Re: Florida Power & Light Company  
Proposed Turkey Point Units 6 and 7  
Docket Nos. 52-040 and 52-041  
Initial Response to NRC Request for Additional Information Letter No. 035  
(eRAI 5681) Standard Review Plan Section 13.03 – Emergency Planning

**NRC RAI Letter No. PTN-RAI-LTR-035**

**SRP Section: 13.03 – Emergency Planning**

**Figure A1-2 Evacuation Routes and Assembly Areas**

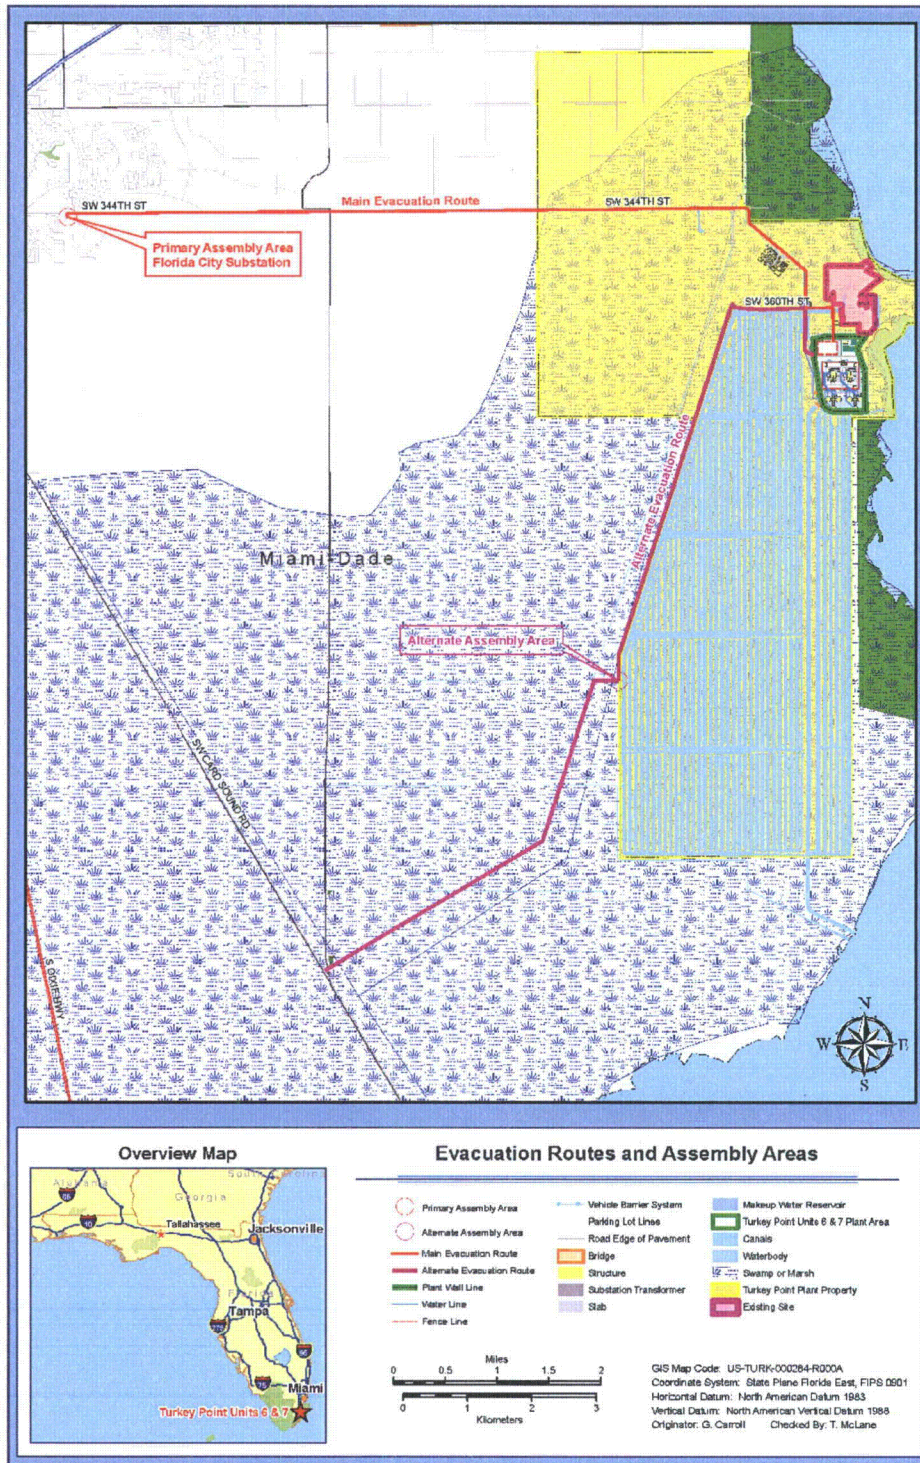
Provide a map in the Emergency Plan that shows the location of the designated offsite assembly areas for personnel evacuating the site. If the assembly areas are not under the applicant's control, provide letters of agreement or other appropriate documentation that addresses their availability during an emergency.

FPL has developed a map that illustrates the primary and alternate evacuation routes from the Turkey Point site. The map will be inserted as a figure into Annex 1, Annex 2, and Annex 3 of the Emergency Plan. A statement identifying the figure will also be added to Annex 1, Annex 2, and Annex 3.

A new sentence and Figure A1-2 will be added after the second paragraph of COLA Part 5, Annex 1, Section 5.3 in a future COLA revision, as shown below:

**The primary and alternate evacuation routes are illustrated in Figure A1-2.**
